ABBREVIATED PLAT AGENDA

**STAFF REVIEW AND RECOMMENDATIONS
PUBLIC HEARING
AUGUST 19, 2026**

ABBREVIATED PLAT: CHUGACH VIEW 2026

REVIEWED BY: MATTHEW GODDARD **CASE #:** 2026-082

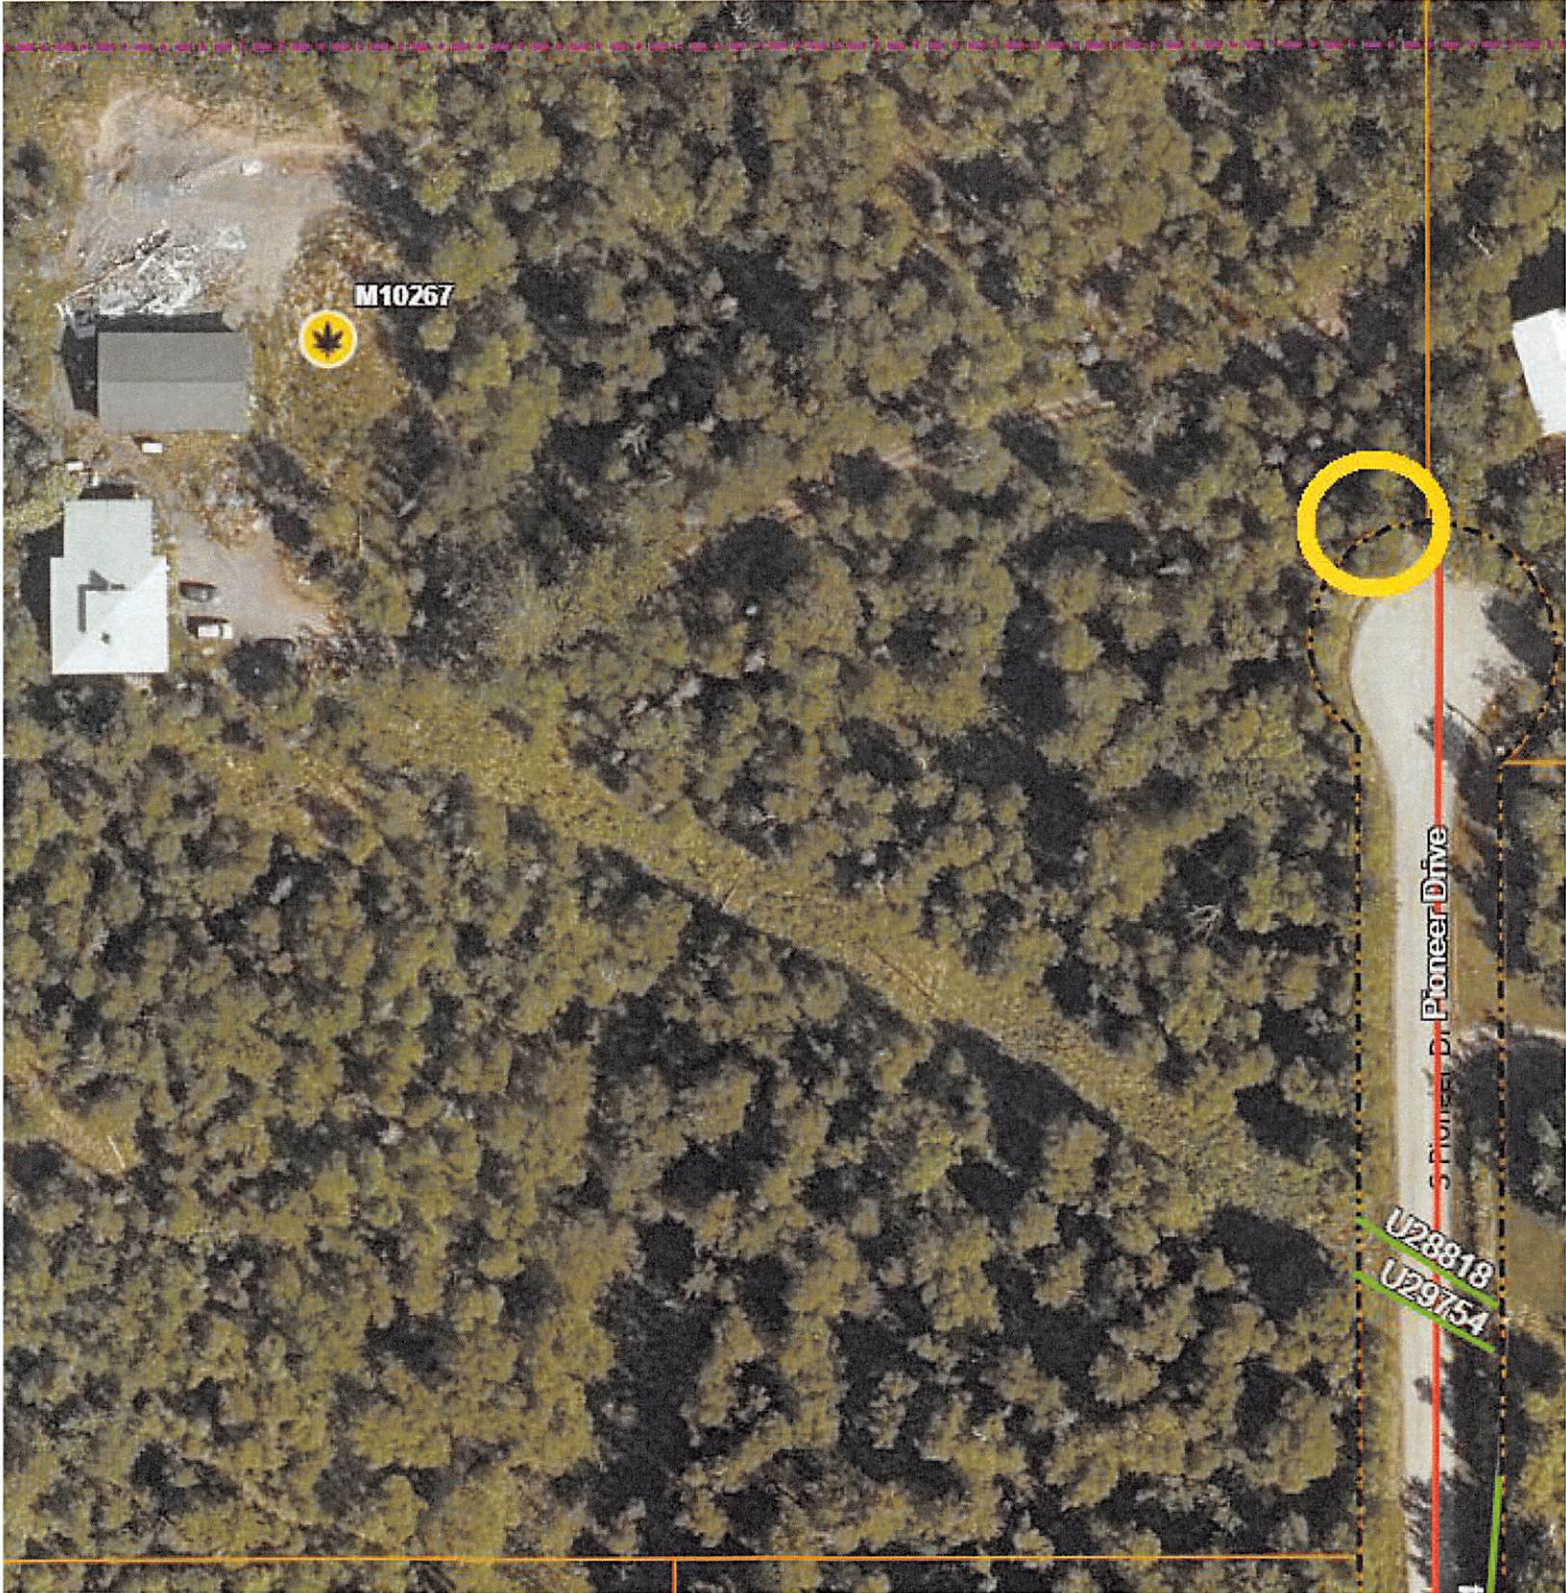
They'll need a DW permit as shown. No other comments from the Permit Center.

Permit Center notes that a driveway permit is needed for the existing access to S. Pioneer Drive (**Recommendation #5**).

Chugach View 2026

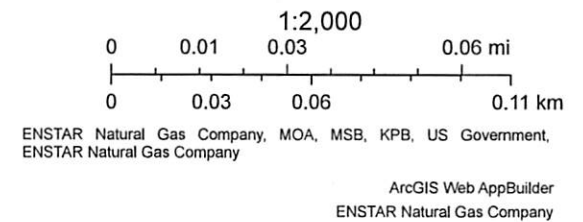
ENSTAR Natural Gas Company, LLC (ENSTAR) has reviewed abbreviated plat Chugach View 2026 (MSB 2026-082) and advises that ENSTAR has existing natural gas service pipeline that crosses proposed LOT 2 to serve proposed LOT 1. Attached is a depiction for your reference. ENSTAR objects to this plat unless one of the following scenarios is met:

1. Grant ENSTAR a ten feet (10 FT) wide natural gas easement centered over the existing natural gas service pipeline within proposed LOT 2 and serving proposed LOT 1.
2. Dedicate a ten feet (10 FT) wide natural gas easement centered over the existing natural gas service pipeline within proposed LOT 2 and serving proposed LOT 1.

Platting Staff notes that an abbreviated plat cannot grant public utility easements. If the petitioner so chooses, they may grant the requested easement by document and the recorded information will be shown on the final plat.

A PLAT OF
CHUGACH VIEW 2026

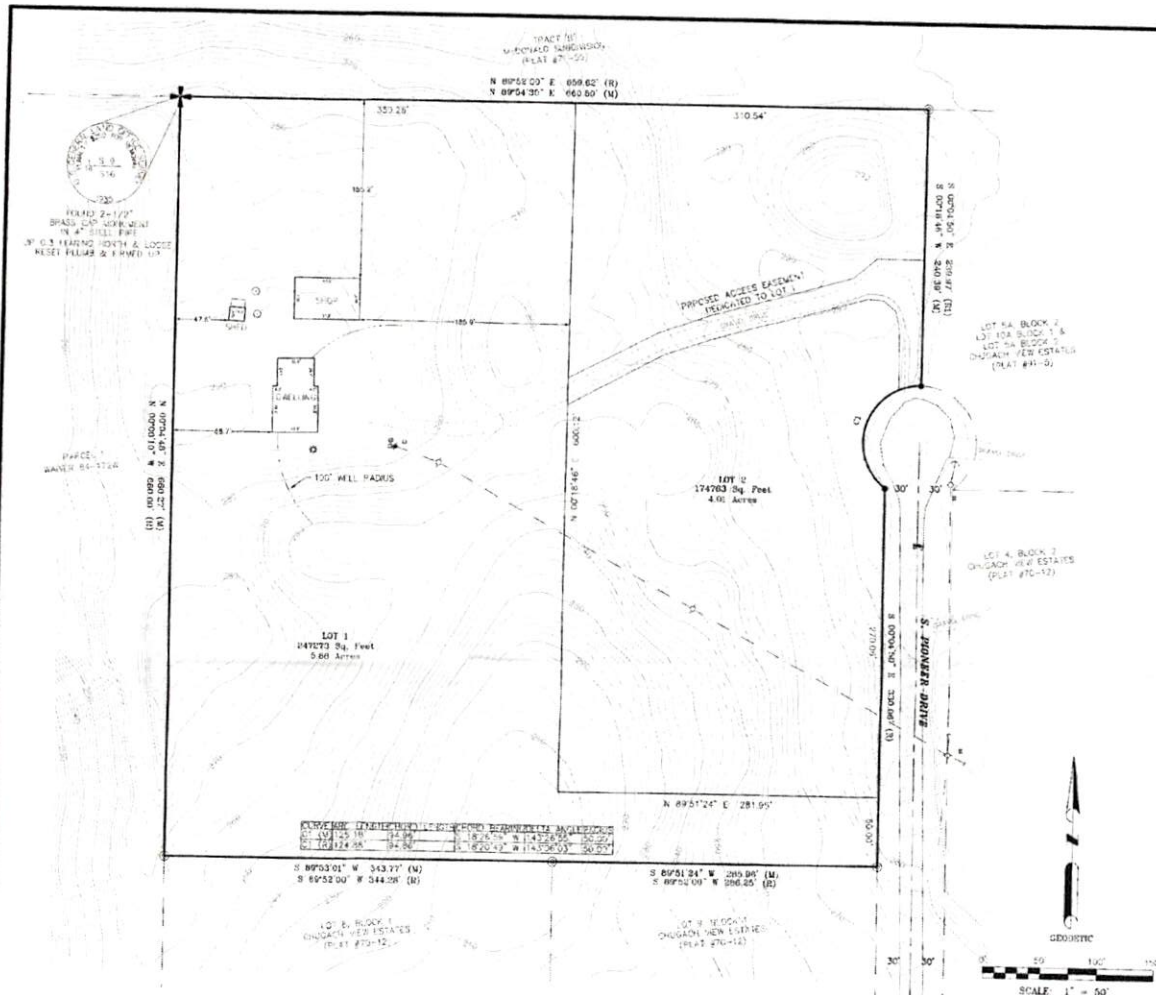
PD&E comments the pole portion of the flag pole lot will need to be 75' wide if it is to include the utility easement along the south boundary of the parent parcel, which has not been identified on the preliminary plat.

MTA would like to request a 15' utility easement where the overhead utilities are shown crossing proposed lot 2.

Department of Public Works (**Exhibit C**) comments that the pole portion of the flag pole lot will need to be 75' wide if it is to include the utility easement along the south boundary of the parent parcel, which has not been identified on the preliminary plat (**Recommendation #4**).

Platting Staff notes that an abbreviated plat cannot grant public utility easements. If the petitioner so chooses, they may grant the requested easement by document and the recorded information will be shown on the final plat.
